MEMORANDUM

From:	Built Heritage Officer		
Service	Green Infrastructure	App No:	251653
Address:	2 Rose Street, Wokingham, RG40 1XU.		
Proposal:	Application for Listed Building Consent for the proposed internal and external repair works including renewing the existing kitchen and bathrooms, repairing and redecoration of windows, repointing and redecoration of external doors, new third floor windows, plus installation of 2no. floor mounted air con units with acoustic screening to rear elevation (part-retrospective)		
Heritage Asset:	Wigmore Lodge, 2 Rose Street – is a grade II listed building and has been since 1951. Wokingham Town Centre Conservation Area. Listed Buildings and conservation areas are classed as designated heritage assets under the NPPF (2024) and in the Council's Local Plan policies.		
Site Visit Made:	Yes, on 22/07/25

Proposed floor plans (extract of drawing E05 rev. P1)

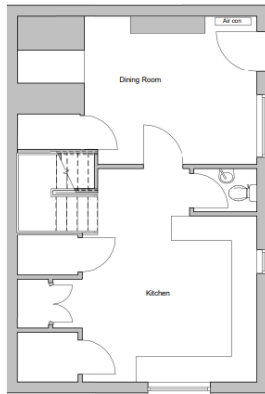
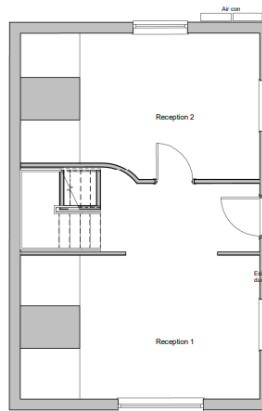
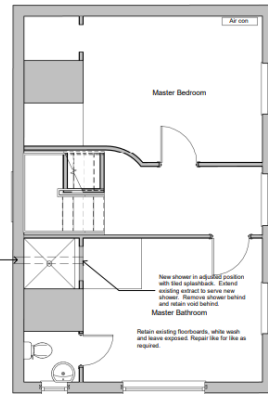
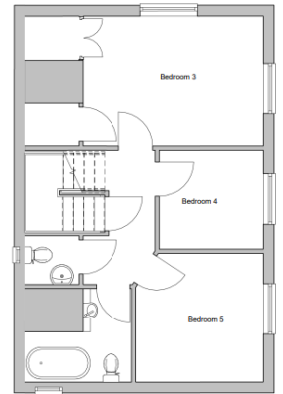
With respect to the submitted existing and proposed floor plans (drawing E05 rev. P1) it has been noted on visiting the property that it appears the staircase leading to the basement/kitchen maybe incorrectly depicted, as the wall either side of the door opening into the dining room of the basement are in line with each other, with the wall abutting directly the bottom of the steps on its RHS. Also it should be pointed out that the proposed floor plan shows a small WC room on the second floor next to the shared bathroom on that floor, however on visiting the property this has been made in to a 'wet room shower facility. Also it is noted the existing and proposed rear elevation does not show the projecting out metal escape ladder from the second floor shown on the NW side elevation. For the avoidance of doubt here it would seem necessary to have the applicant either amend the drawing accordingly and/or confirm in writing that the escape ladder remains in place.
